Martin Elementary School Modernization
Project No. 01-19
Addendum No. 2
DSA Appl. # 01-116977
April 2, 2019

ADDENDUM NO. 2

12 DEMOLITION FLOOR PLAN - BUILDING E
1/8" = 1'-0"

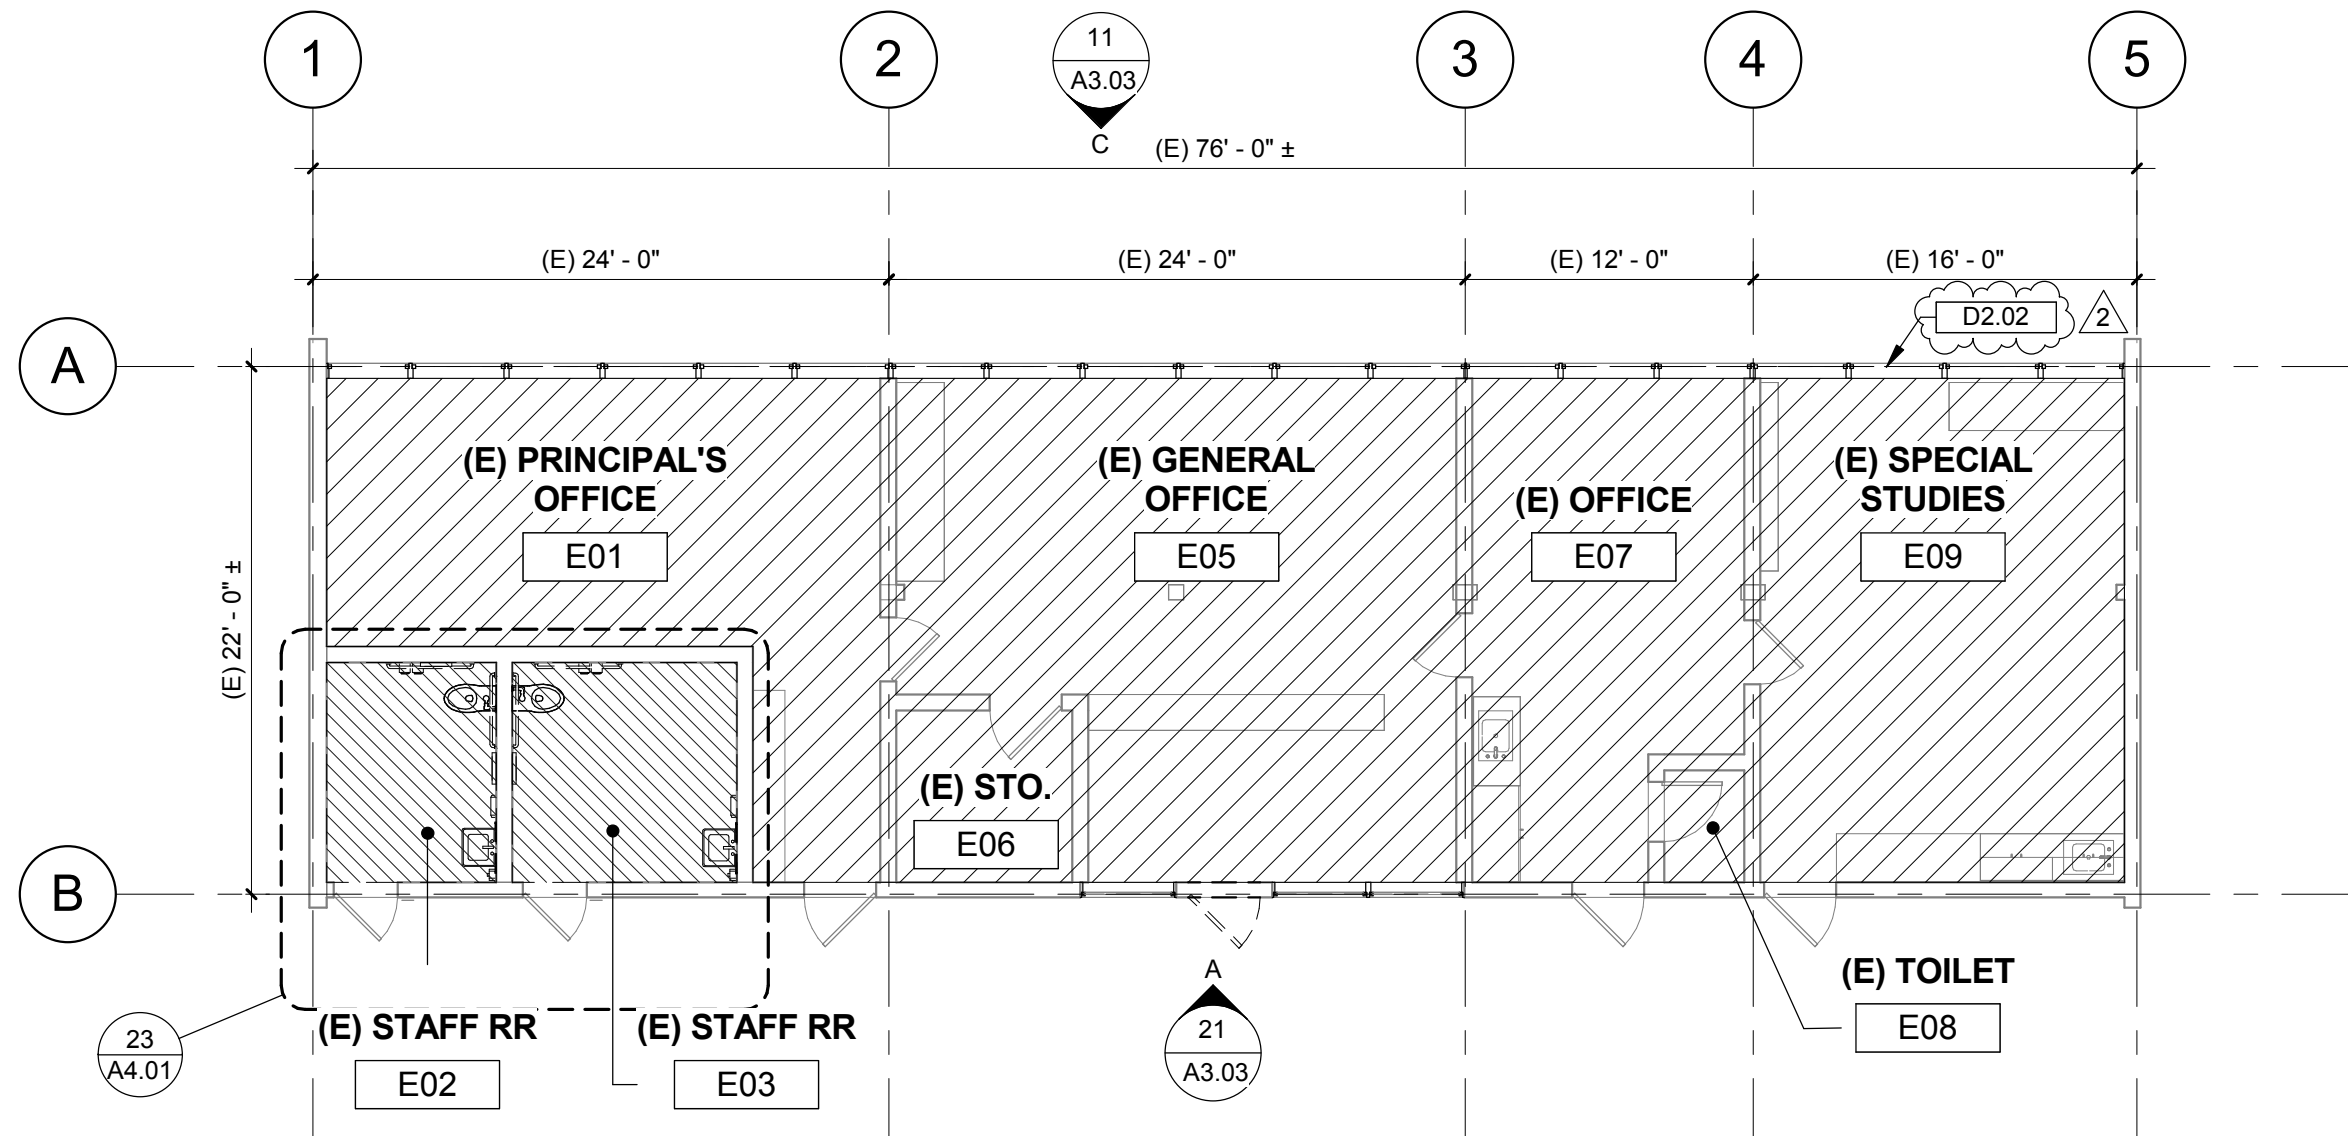
Item No. AD-2.18: Drawing Sheet A2.01 DEMOLITION FLOOR PLANS BUILDINGS A & E – Detail 12

- A. **Add** Keynote D2.02 to DEMOLITION FLOOR PLAN - BUILDING E to align with Demo Elevation Details 11 & 21/A3.03 for building E. See **Attached** A2.01.

DSA APPL. #01-116977
DSA FILE # 41-28
DATE: 04/02/19
REF.: 13/A1.01
SCALE: 1/8" = 1'-0"
DRAWN BY: OA
SHEET:
ASK-01

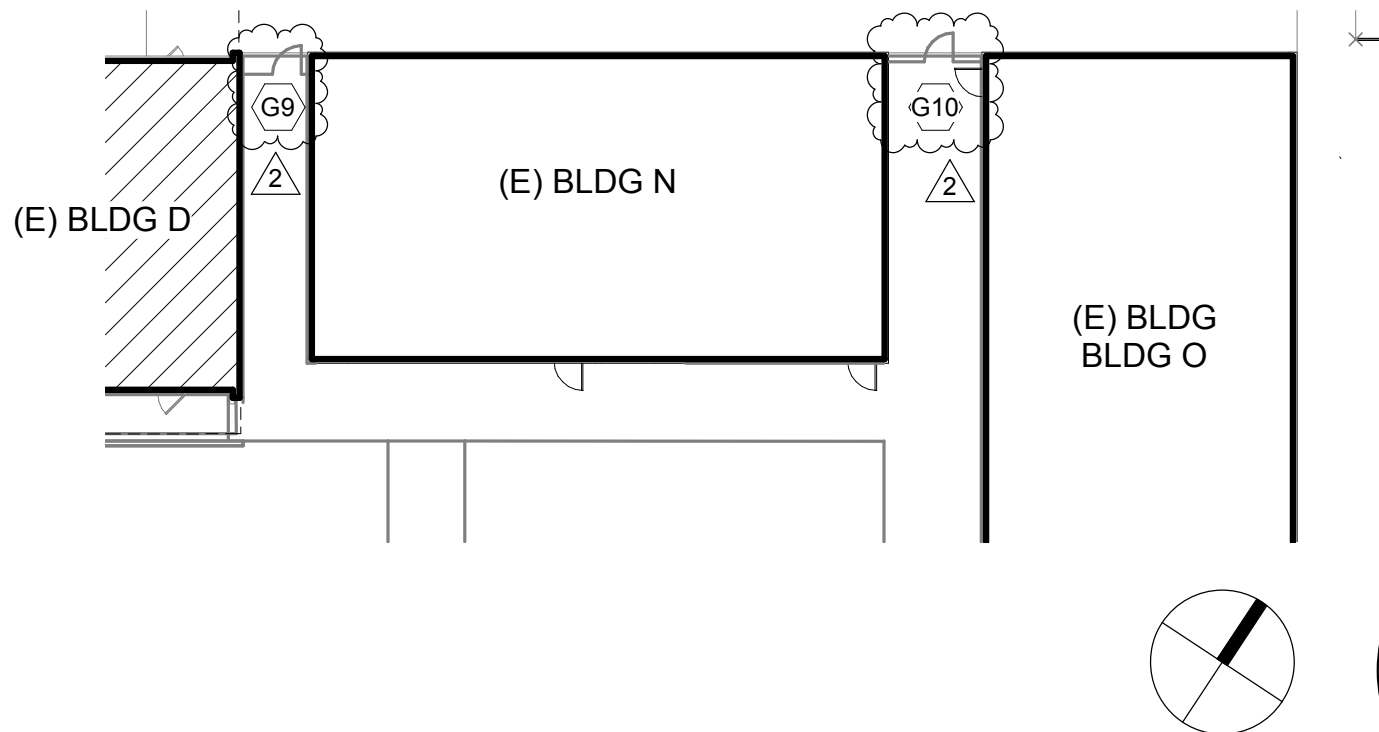
Item No. AD-2.13: Drawing Sheet A1.01 SITE DEMOLITION PLANS – Detail 13.

- A. **Add** Keynotes D2.23 & D2.30. See **Attached** ASK-01.

- D2.23 REMOVE (2) (E) ABANDONED INTERCOM CONDUITS ALONG COVERED WALK BACK TO (E) MECH ROOM C07.
D2.30 REMOVE (E) ABANDONED GAS PIPE ALONG COVERED WALK.

DSA APPL. #01-116977
DSA FILE # 41-28
DATE: 04/02/19
REF.: 25/A1.02
SCALE: 1" = 20'-0"
DRAWN BY: OA
SHEET:
ASK-02

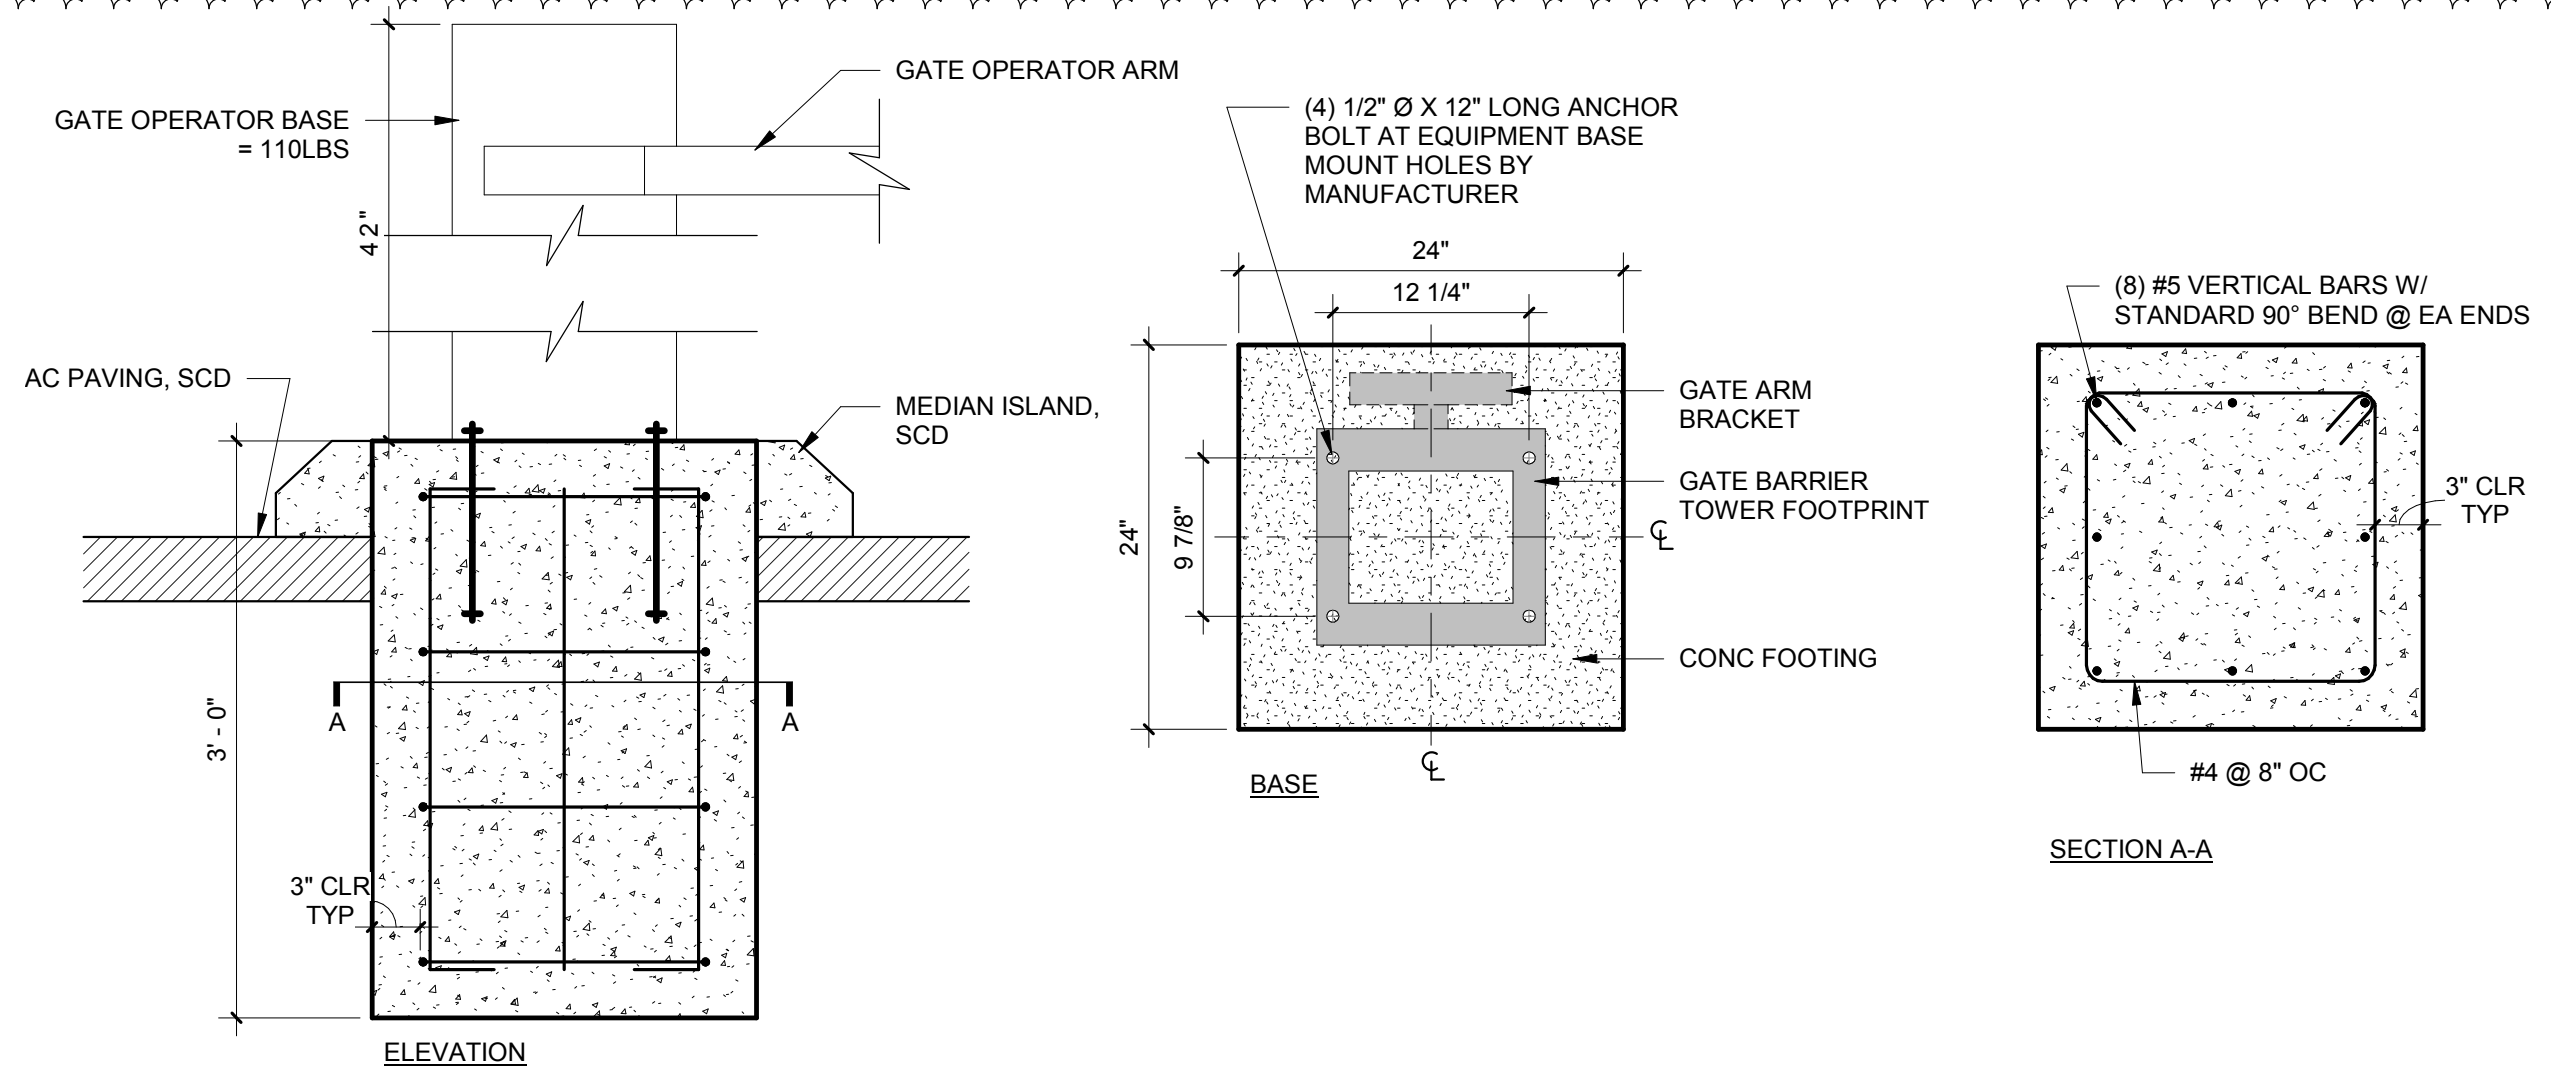
Item No. AD-2.14: Drawing Sheet A1.02 OVERALL AND ENLARGED SITE PLANS – Detail 25.

A. **Add** Gates G9 & G10. See **Attached** ASK-02.

DSA APPL. #01-116977
DSA FILE # 41-28
DATE: 04/02/19
REF.: A1.02b
SCALE: 1" = 1'-0"
DRAWN BY: OA
SHEET: ASK-03

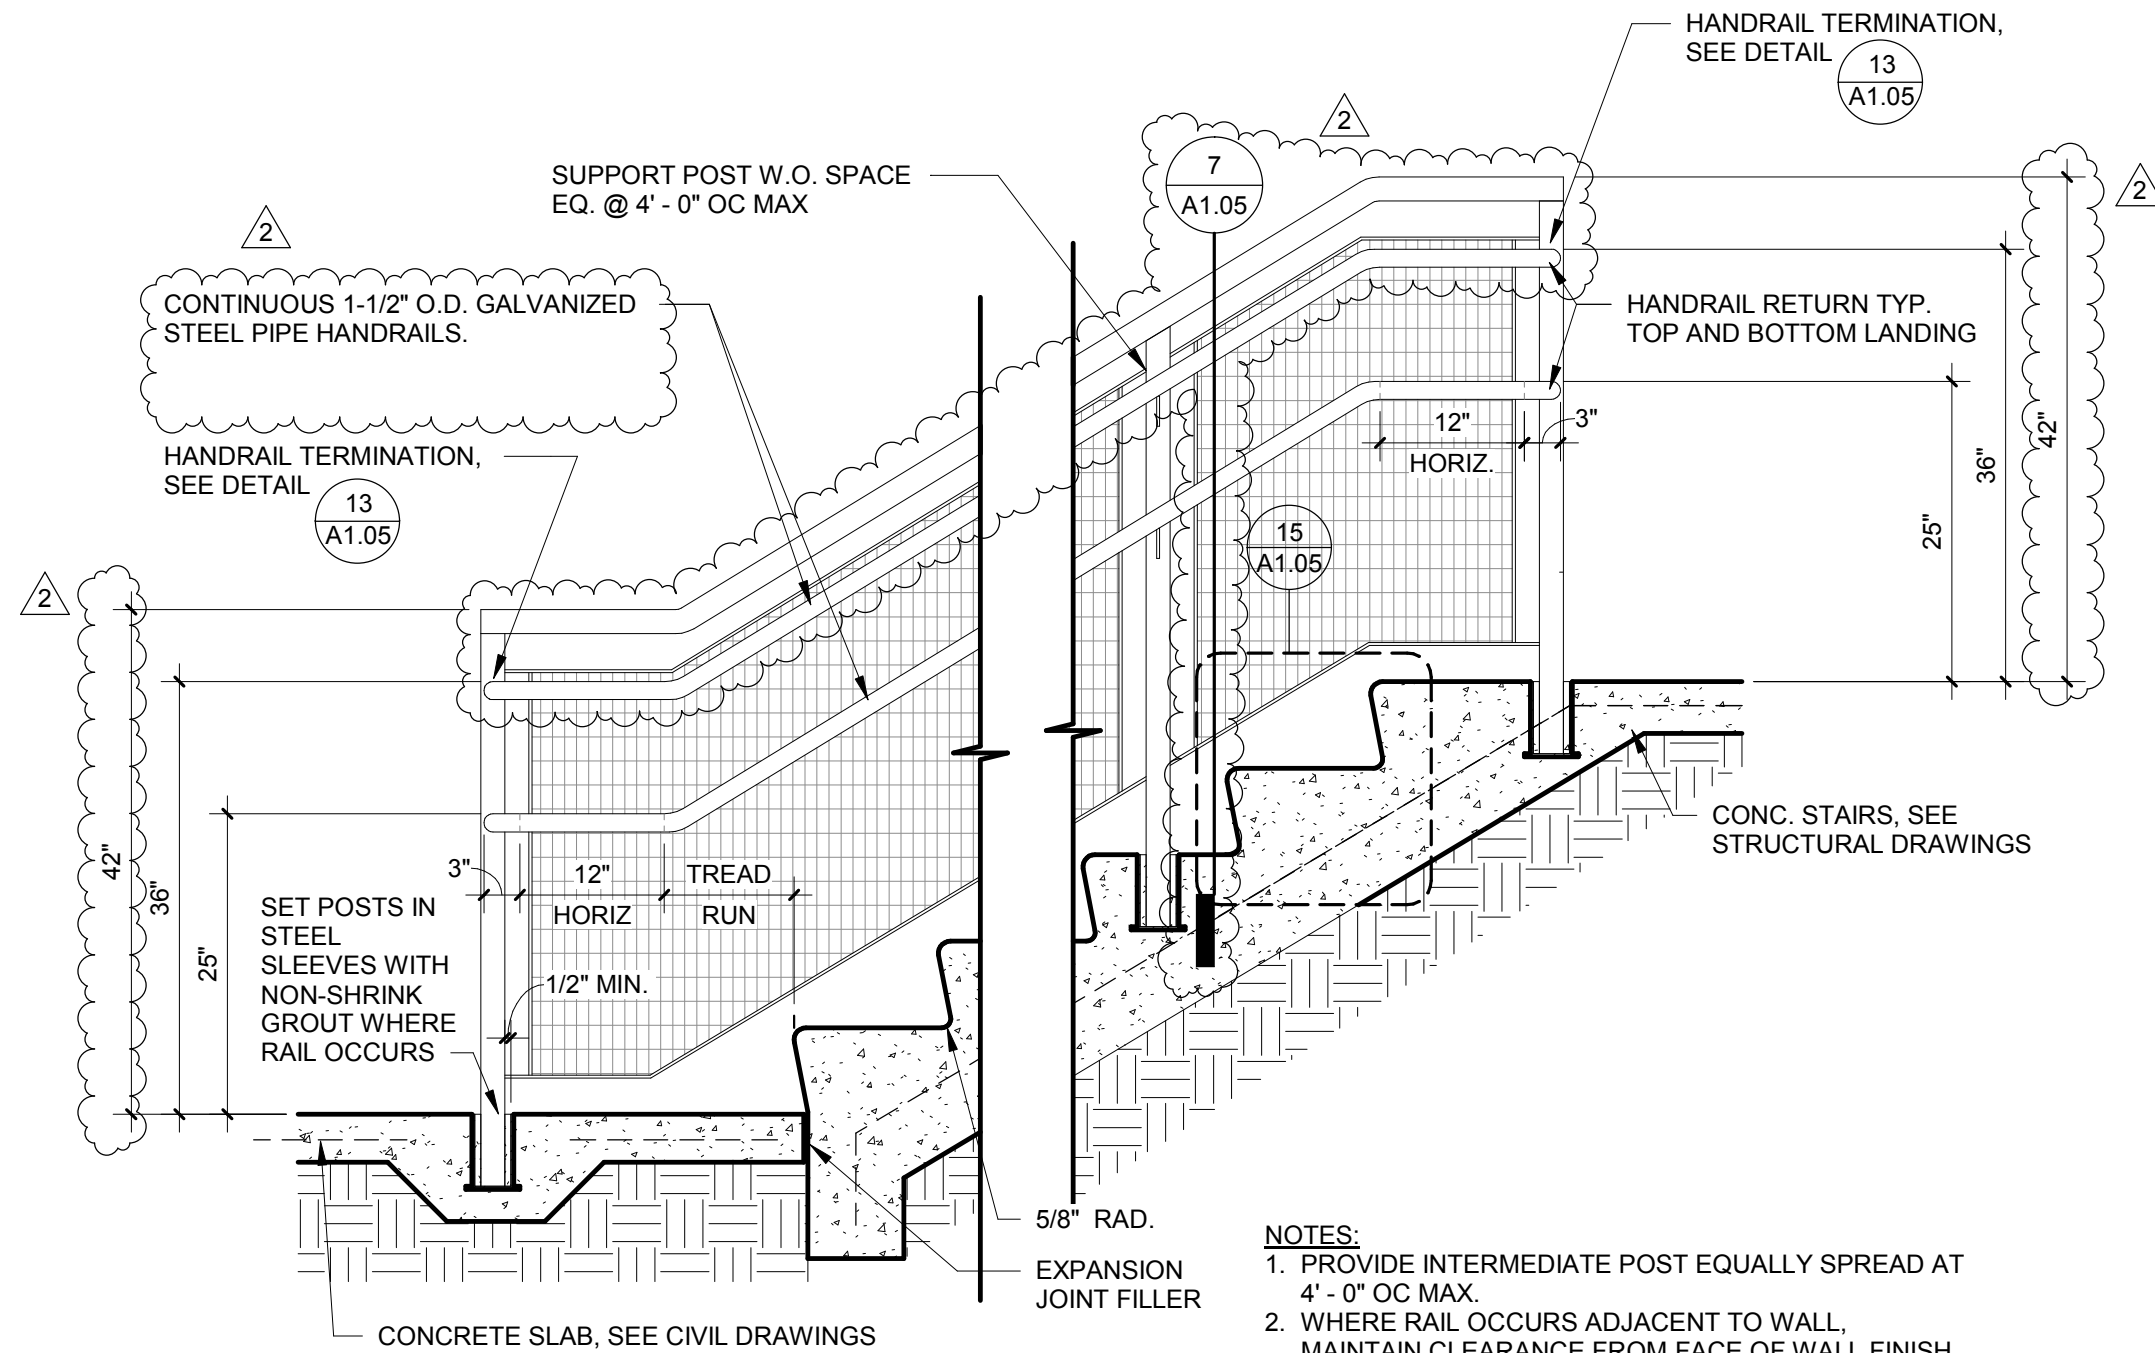
Item No. AD-2.15: Drawing Sheet A1.02b ENLARGED SITE PLANS

- A. **Add** Detail 11 GATE BARRIER POST FOOTING DETAILS. See **Attached** ASK-03.
- B. Detail 27/-: **Revise** Note 3 to Read 'PARKING BARRIER OPERATOR. SEE DETAIL 11/-.'

REF.: 22/A2.41

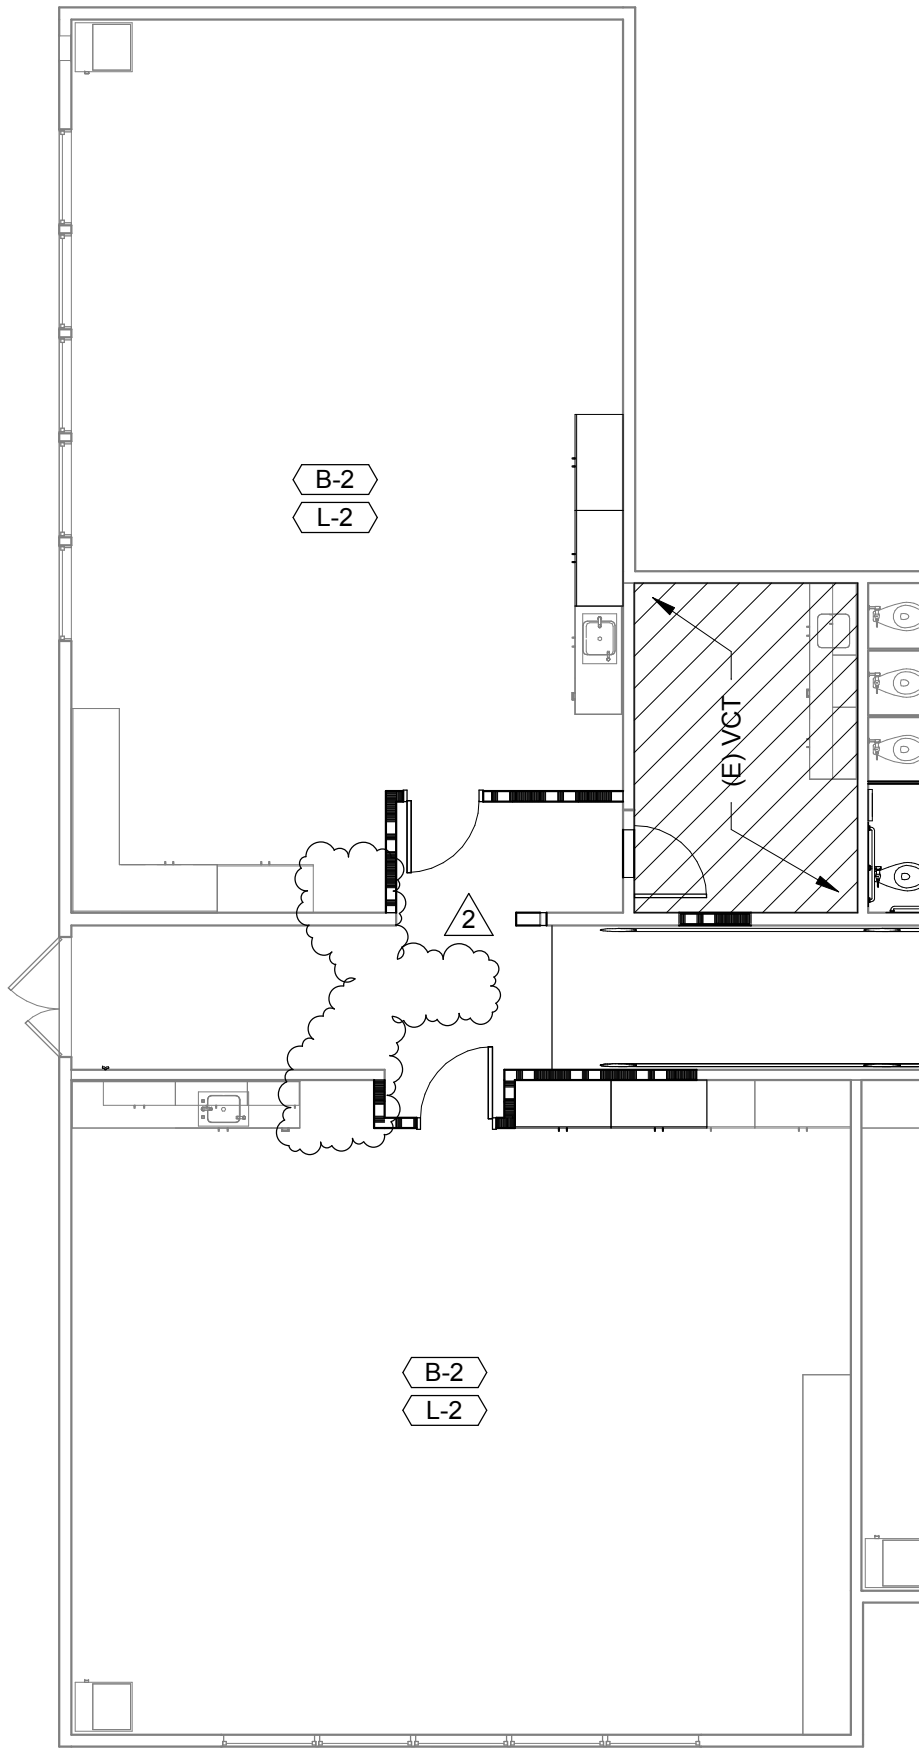
C. **Add** Detail 22 for a typical portable classroom floor finishes plan. See **Attached** ASK-06.
